# EXHIBIT E - ANPCC Site Layout Drawing

**1 SITE PLAN - EXISTING**  
Scale: 1/32" = 1'-0"

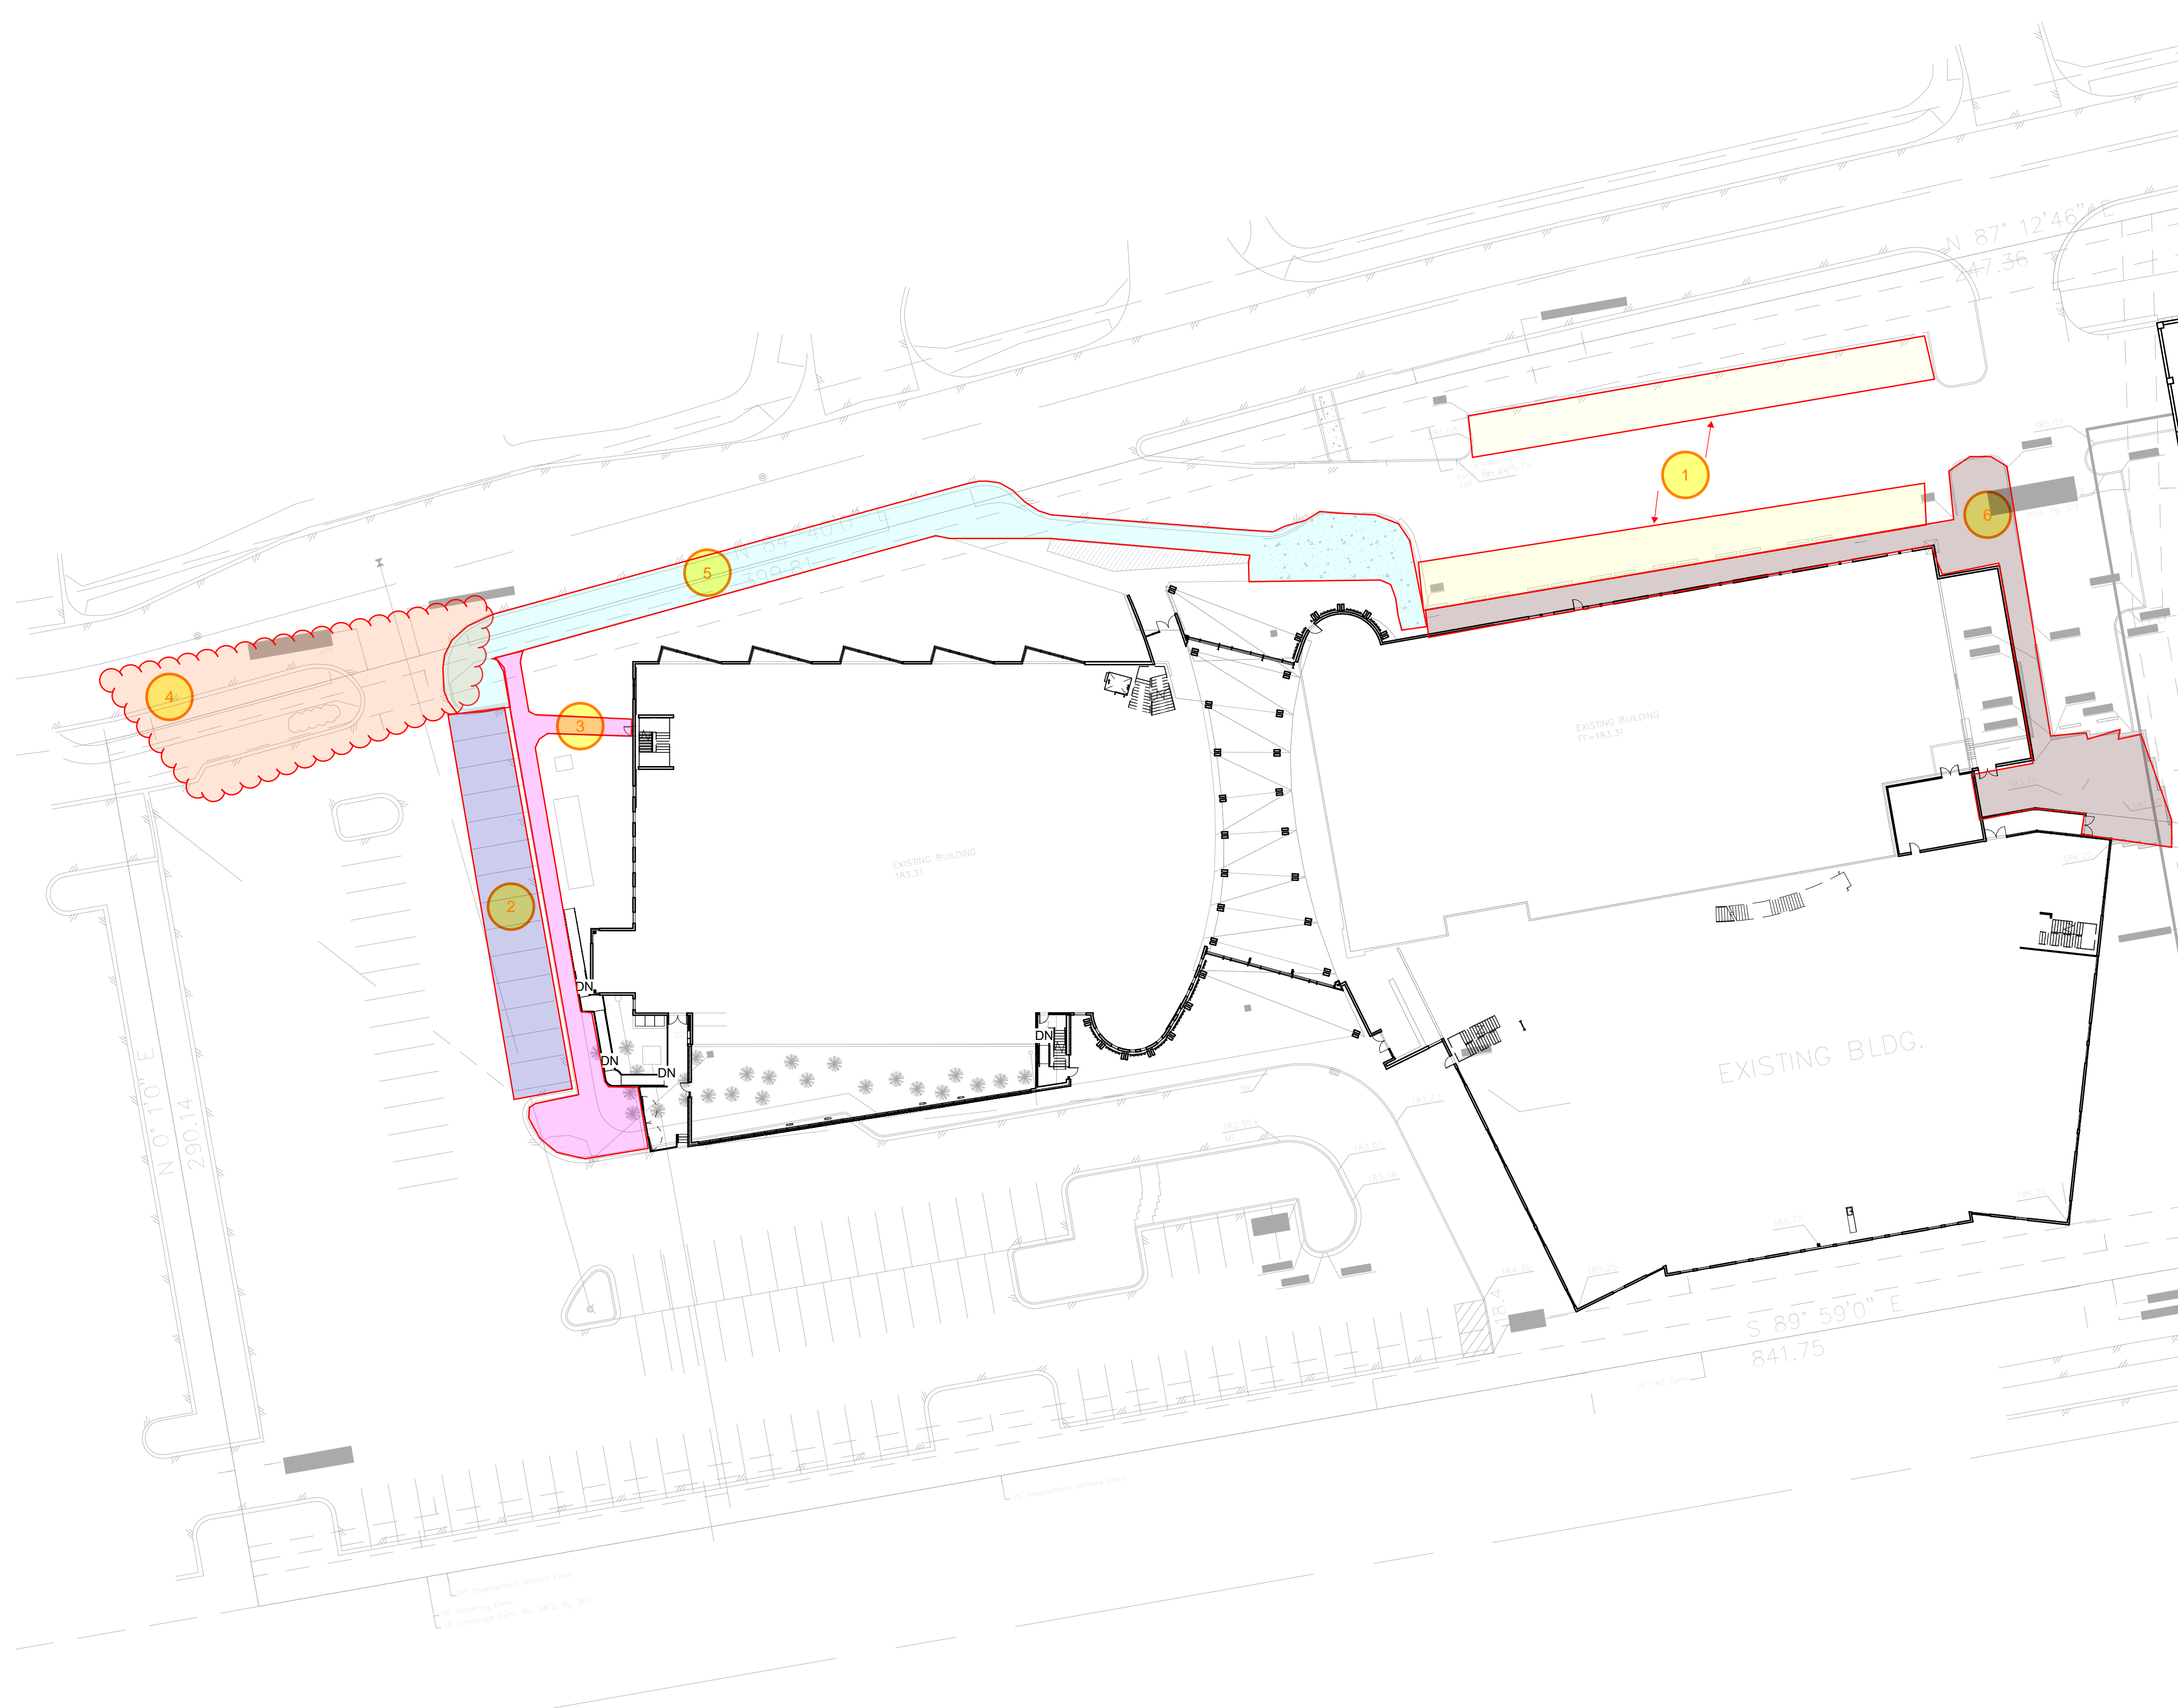
Note 1: Existing handicapped spaces (closest to the building) are not code compliant. Change layout as allowed by codes and site to make handicapped spaces compliant. Maintain minimum of 12 handicapped spaces. Add pedestrian protection near building. Existing parking bumpers are not adequate. Retain Elder Parking spaces (further from building) and revise layout to make parking spaces code compliant. Avoid disruption of adjacent sidewalk containing existing snow melt loop.

Note 2: Existing spaces are not code compliant due to sidewalk bumpout (not accurately shown on this drawing). Change layout as allowed by codes and site to make compliant. The two spaces furthest North shall be handicapped spaces. The Southwest corner of the building and sidewalk ramp are newly constructed and shall not be disturbed.

Note 3: Demolish and replace this section of curb and sidewalk. Snow melt system to be added/extended to this section of sidewalk.

Note 4: Modify entrance if/as required to keep compliant with all codes.

Note 5: Demolish and Replace curb/gutter and sidewalk. Include addition/extension of snow melt system for this sidewalk. Note there is an existing snow melt system in the eastern portion of this section. See EXHIBIT G.

Note 6: Do not disturb existing snow melt system in this area.
